WCAP-12392

WESTINGHOUSE BOILING WATER REACTOR
EMERGENCY CORE COOLING SYSTEM EVALUATION MODEL:
CODE SENSITIVITY

SUBJECT: ACCEPTANCE FOR REFERENCING OF LICENSING TOPICAL
REPORTS WCAP-11284 AND WCAP-11427 REGARDING THE
WESTINGHOUSE BOILING WATER REACTOR EMERGENCY
CORE COOLING SYSTEM EVALUATION MODEL

Figure 5-1 Normalized Assembly Differential Pressure vs Time

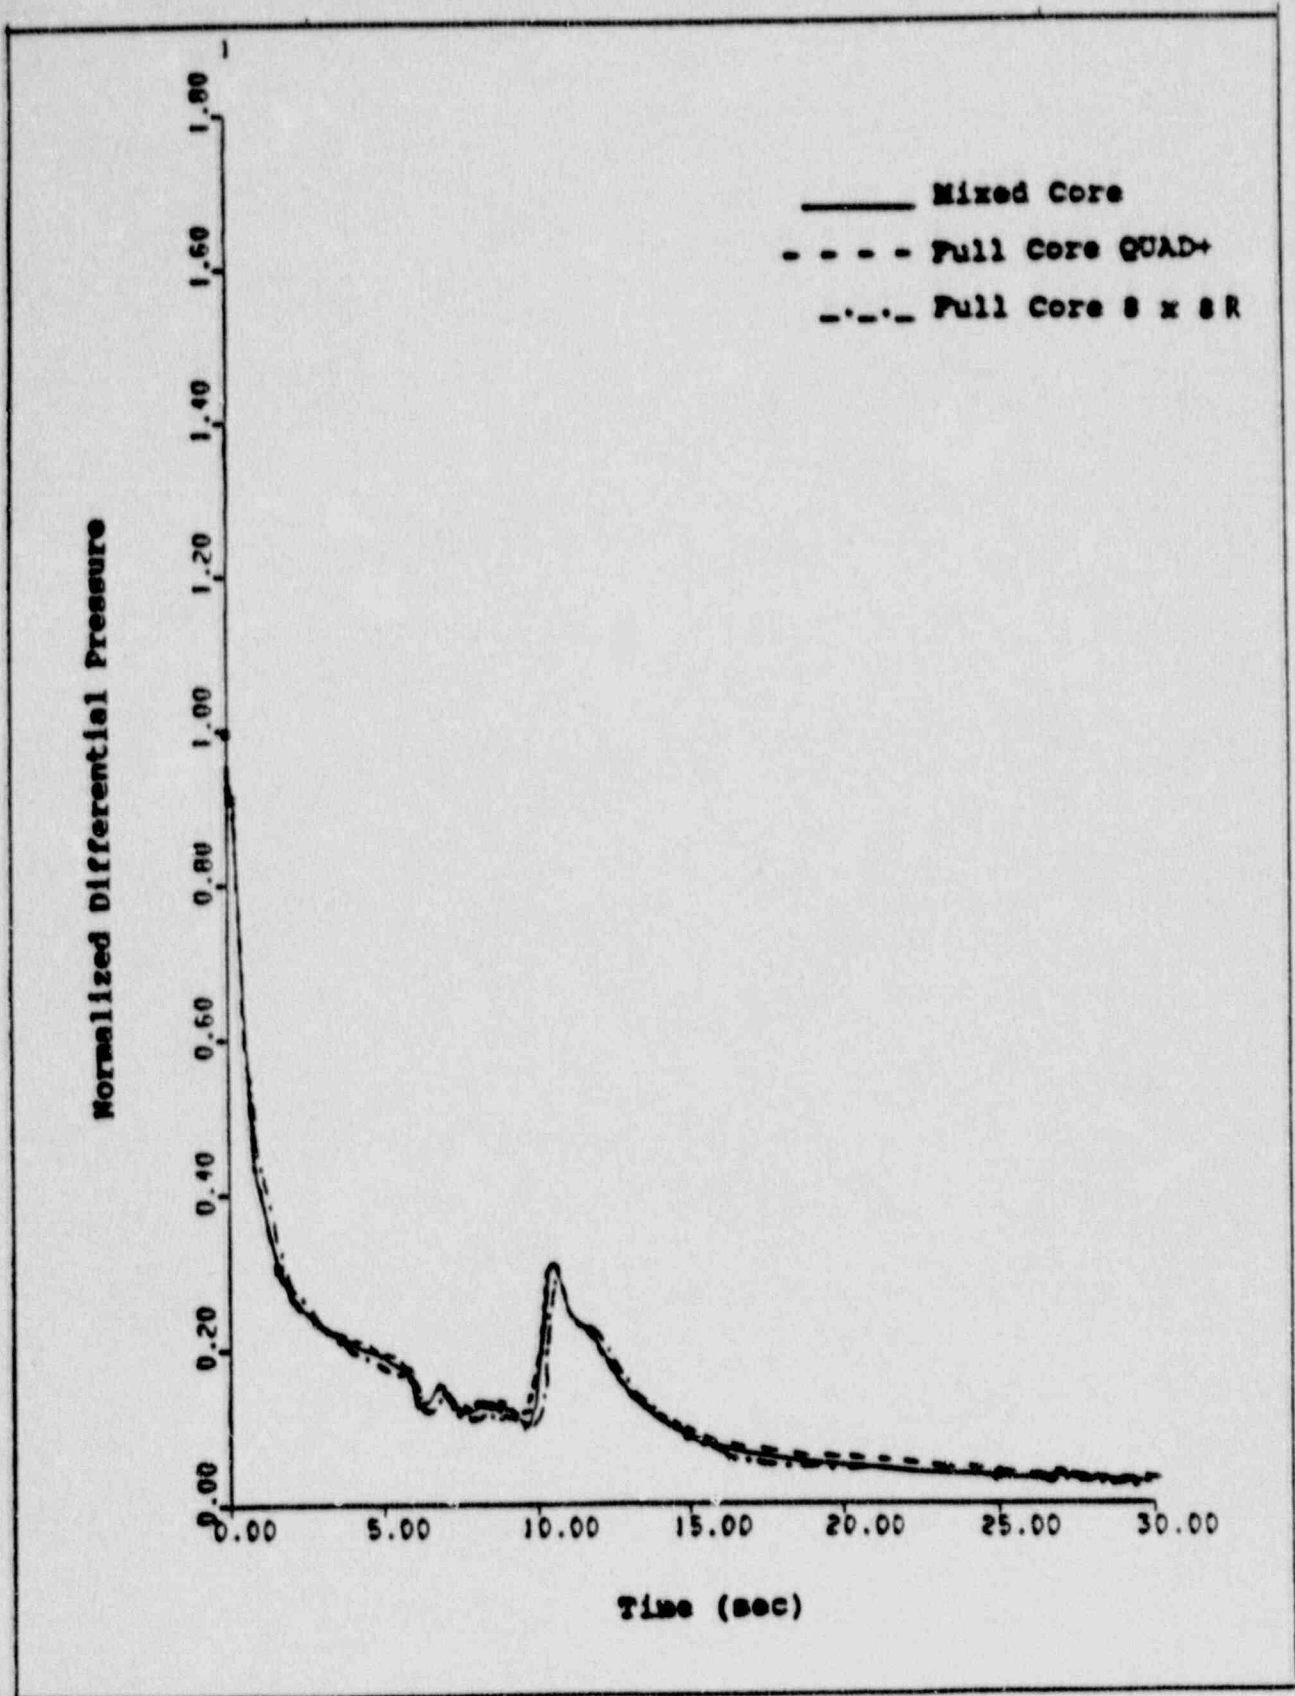
The attached figures present a comparison of the mixed core response to the full core response for each fuel type. Figure 5-1 shows the normalized total core differential pressure during the blowdown for the mixed core and both full core analyses. The core responses compare very well. Figure 5-2 shows the side entry orifice flow (per assembly) for each analysis which also compare very well. These figures demonstrate that the blowdown response is essentially the same for the three transients.

Figure 5-3 Normalized Side Entry Orifice Differential Pressure vs Time

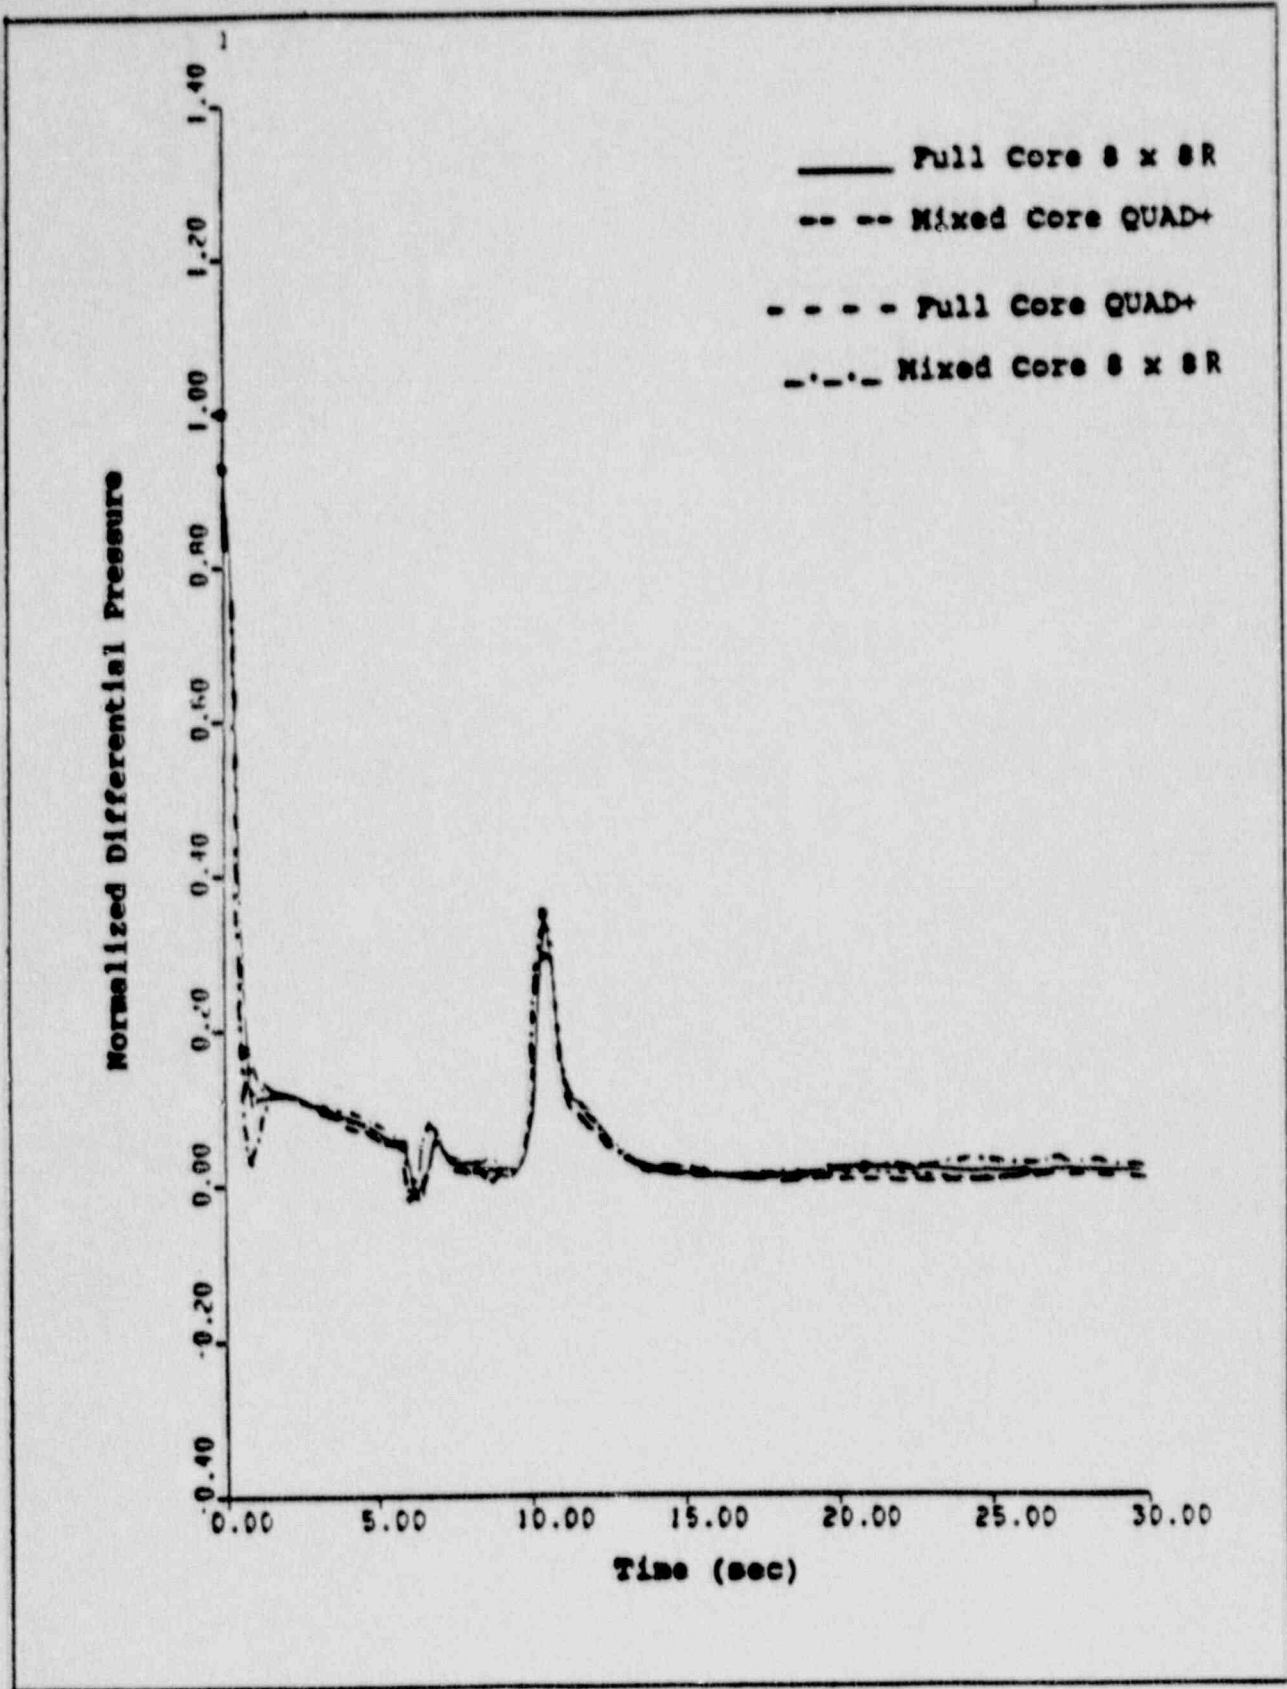
The normalized component differential pressures along the fuel assembly are shown in Figures 5-3 through 5-6. Figure 5-3 shows the pressure difference

across the side entry orifice for the different fuels. As expected, they agree well. The pressure drop across the lower tie plate is shown in Figure 5-4. The magnitude of the responses are different due to the different tie plate designs, but the same trend is followed for each fuel design. Figure 5-5 presents the pressure drop across the heated length of the assembly. Again the trends are the same, although the QUAD+ grid spacers are less restrictive than the 8 x 8R spacers. Figure 5-6 presents the upper tie plate response for the three transients. The less restrictive upper tie plate for the QUAD+ design is prominent at 10 seconds when lower plenum flashing begins. These figures show that although the individual component pressure drops may vary between fuels, the transient trends are essentially the same.

Figure 5-7 Core Void Fraction at 20 Seconds vs Core Elevation

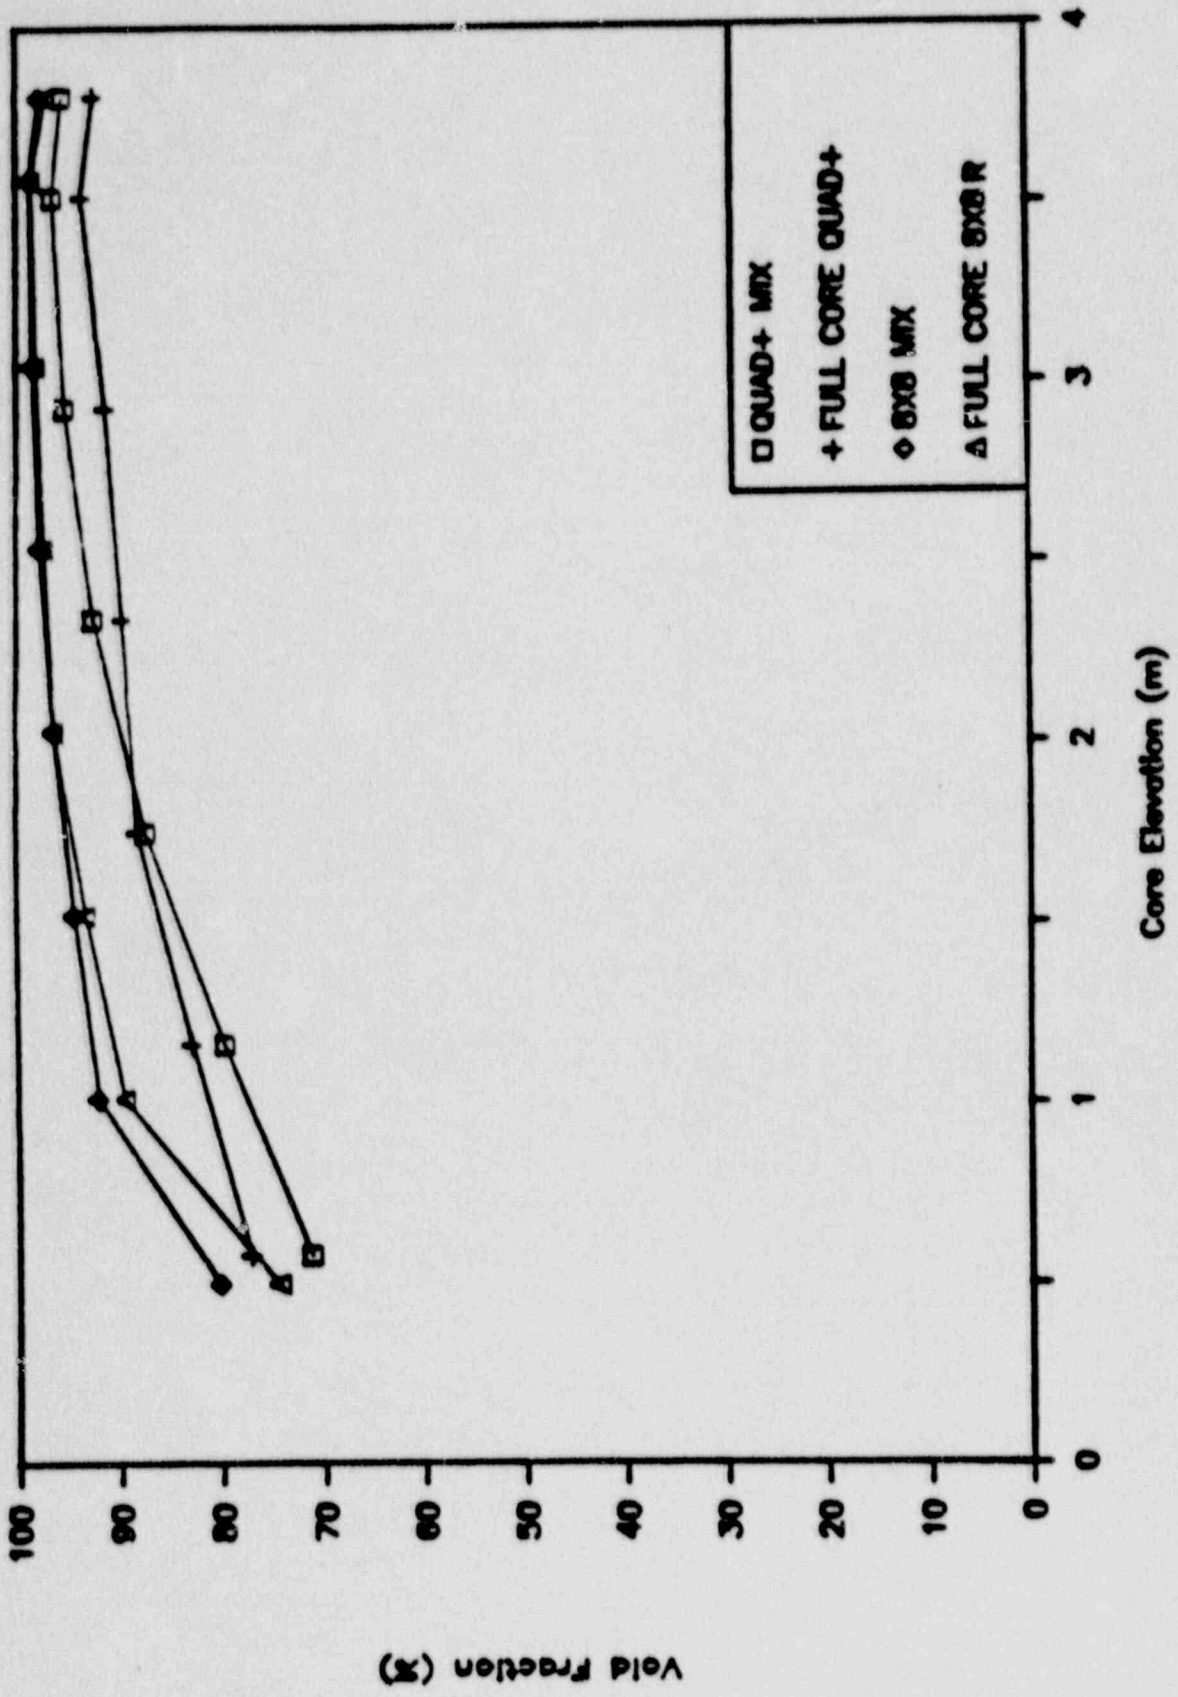
Figure 5-7 shows a comparison of the void distribution throughout the fuel assemblies at 20 seconds into the transient. Twenty seconds is just prior to midplane dryout, when the mass distribution in the bundle is important. It can be seen that since the transients are very similar, the mixed core does not significantly alter the individual assembly mass distributions. Because the mass distribution does not vary considerably, the dryout times for each transient are comparable, as seen in Table 9.1 of Ref. 2.

Figure 5-8 Normalized Assembly Differential Pressure vs Time

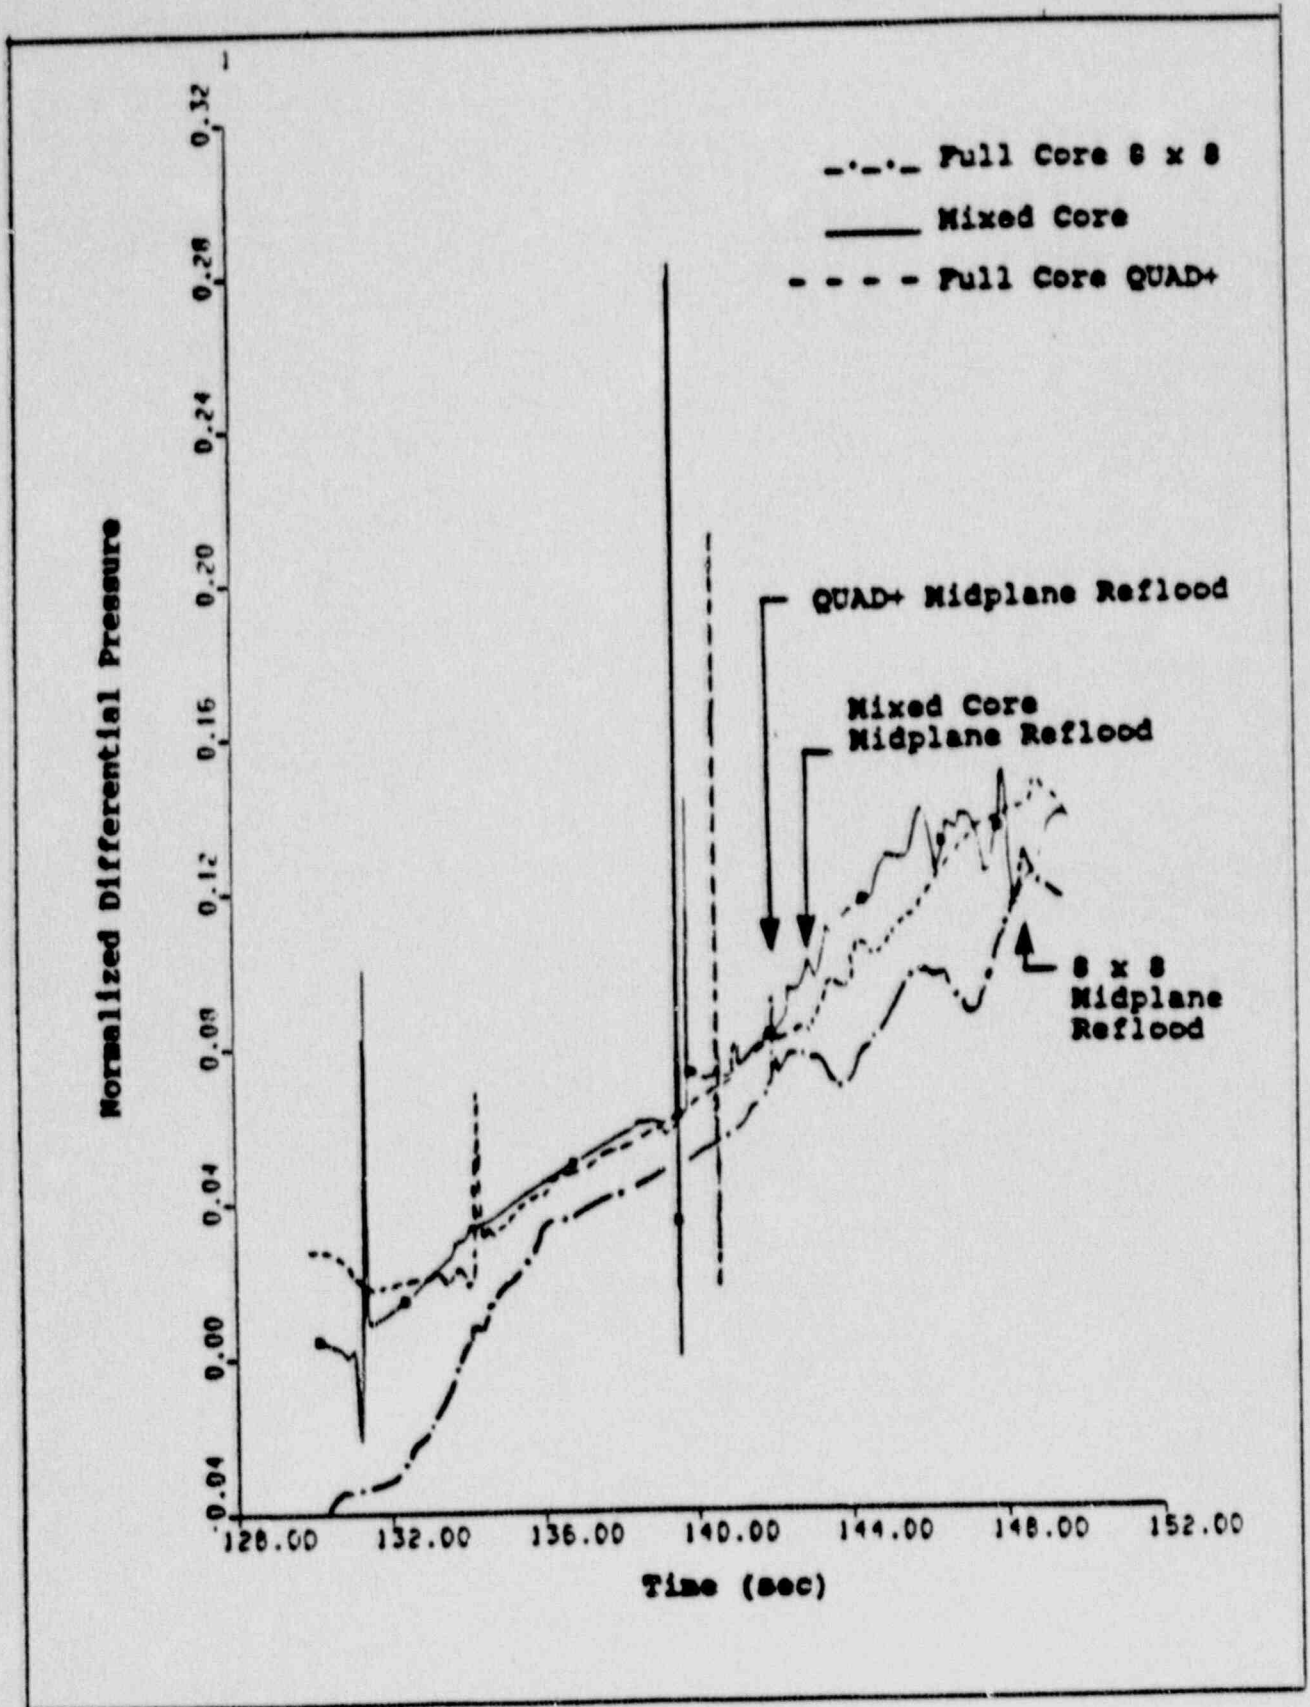
The midplane reflood portion of the transient is presented in Figure 5-8. Figure 5-8 shows the normalized total core differential pressure for the three transients from 130 to 150 seconds. The midplane reflood times for each case are indicated in the figure. These times compare well due to the similarity in the system mass distributions for each case. It can be seen that the driving force for reflooding the core is essentially the same for each transient.

Figure 7-2 Midplane Coolant Pressure for Reference Transient

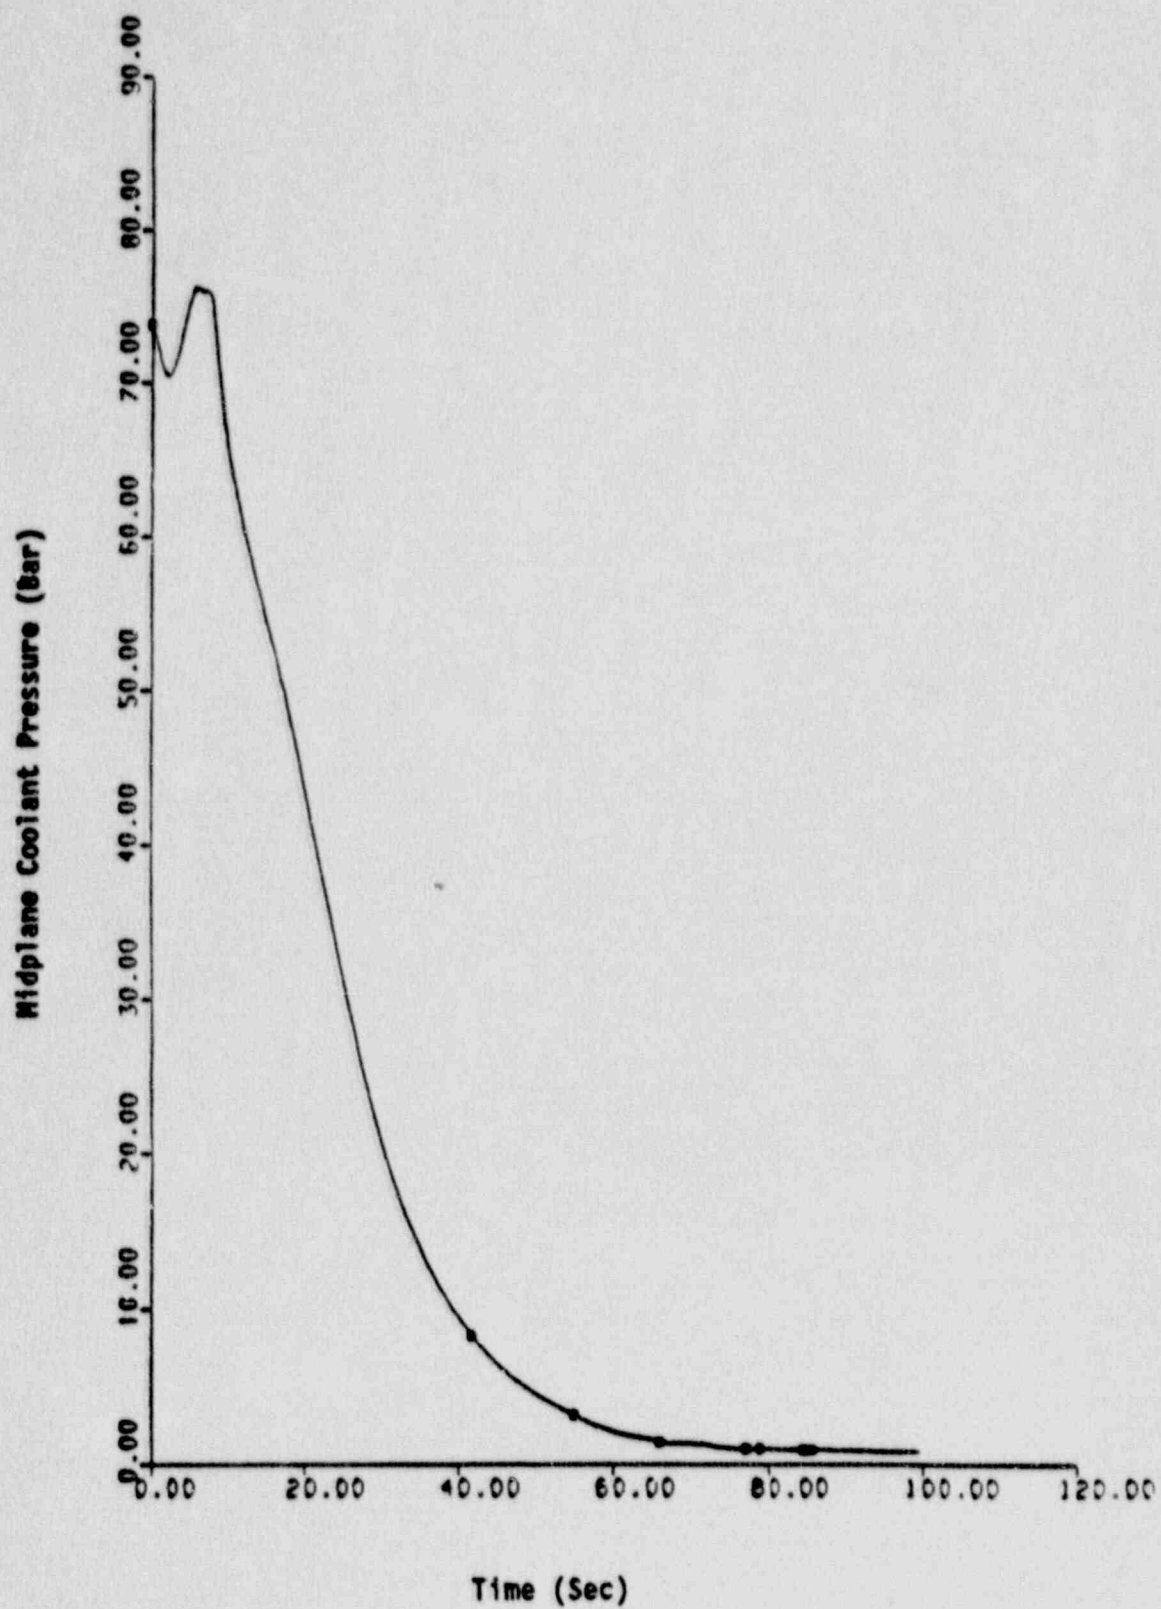
The cladding heatup for the hot rod for 0 to 100 seconds of the reference case is shown in Figure 7-1. The core midplane coolant pressure transient is shown in Figure 7-2. The rod internal pressure is shown in Figure 7-3. A comparison of Figures 7-2 and 7-3 shows that the rod internal pressure exceeds the coolant pressure after 30 seconds. This is reflected in the cladding stress, shown in Figure 7-4. This figure also shows the allowable cladding stress versus time, and the intersection of the actual and allowable stress curves at 98 seconds. The swelling of the cladding prior to burst is shown in Figure 7-5. The rapid swelling from 73 to 98 seconds is due to the plastic deformation of the cladding.
